S16YN

Subject: S16YN
Rear Air Disc Brake Axle Shaft Flange Nut Replacement

Models Affected: Model Year: Certain 2015-2017
Model: Vision and All American
School Bus and Non-School Bus

REAR AIR DISC BRAKE

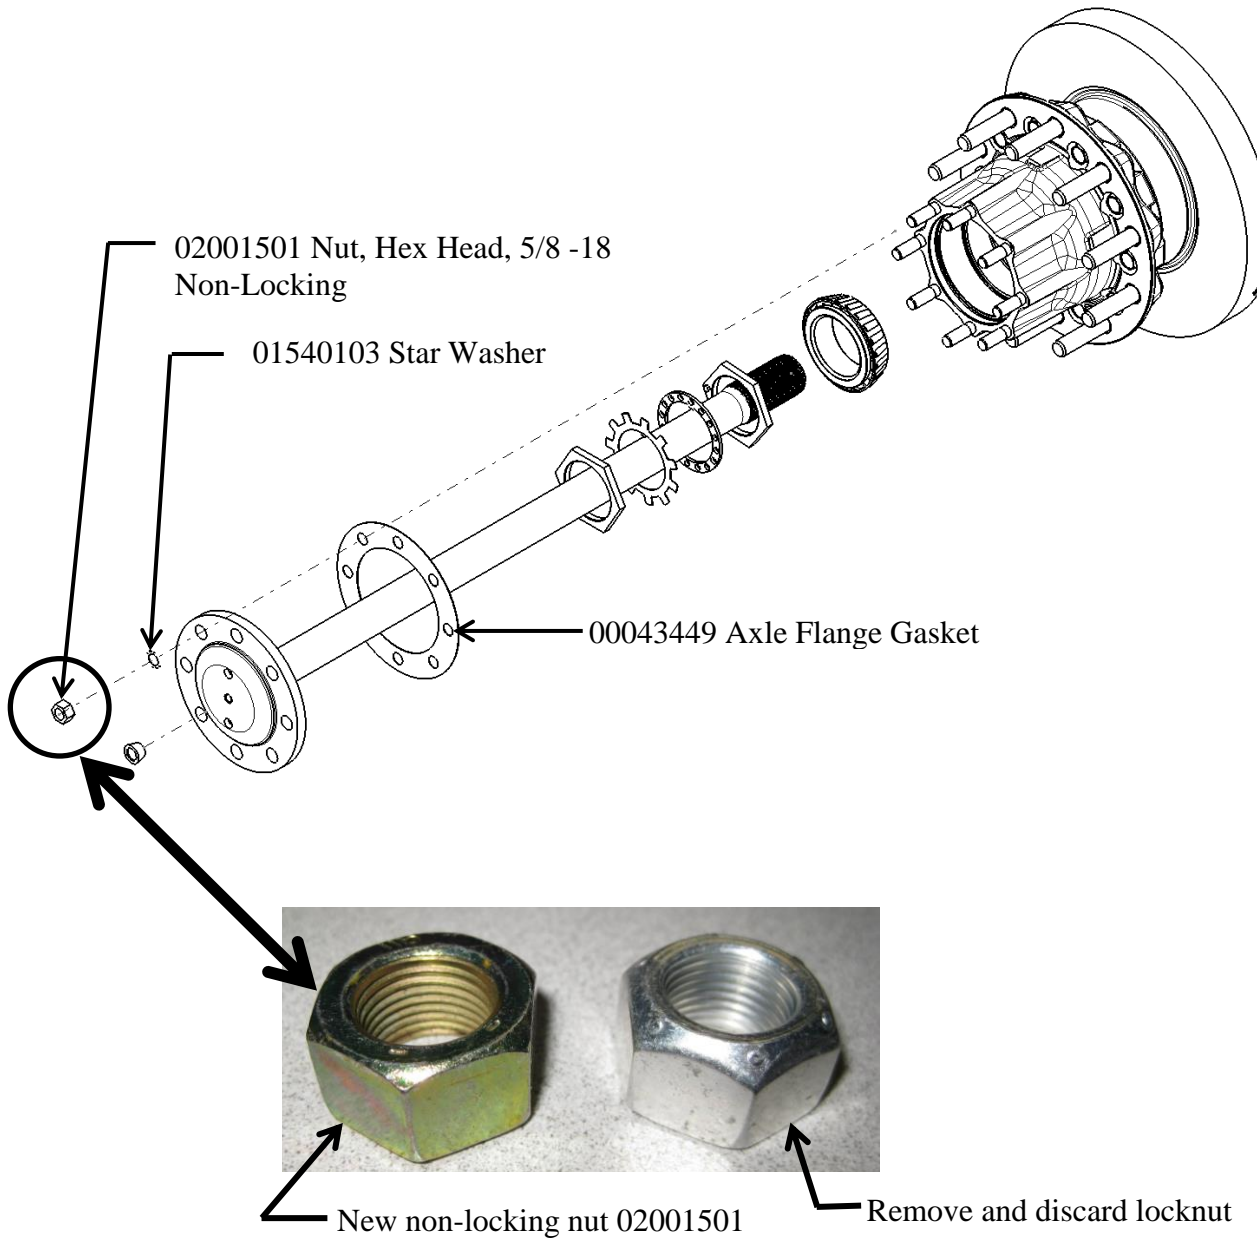
Rear axle shaft flange nut torque reduces allowing for oil leak between the axle shaft and hub.

Replace the existing rear axle flange lock nut with a new non-locking nut and star washer. Request that the Service Manual be updated by technician to show new nut and torque.

1. Park bus on level surface, turn off engine, remove ignition key, and chock wheels.
2. To reduce the possibility of the stud being removed when removing locknut, remove the paint from the existing rear axle shaft flange studs.
3. Remove and discard the first lock nut and star washer.
4. Replace the hardware in Step 3 with a new star washer 01540103 and a new non locking nut 02001501.
5. Torque nut to 60-70 ft-lb.
6. If a stud comes out during removal of locknut, remove the locknut from the stud and reinstall the stud into the hub. Torque stud to 60 to 70 ft-lb.
7. Remove the next lock nut and star washer in a “star” pattern.
8. Repeat Steps 3 to 6 until all eight star washers and lock nuts are replaced.
9. Re-torque all nuts to 170-180 ft-lb. in a “star” pattern.

NOTE 1: If there is a leak at the rear axle flange gasket, remove and discard all eight locknuts and star washers. Replace gasket, install axle shaft, and install eight new star washers 01540103 and new non-locking nuts 02001501. Torque all eight nuts per Step 9 above.
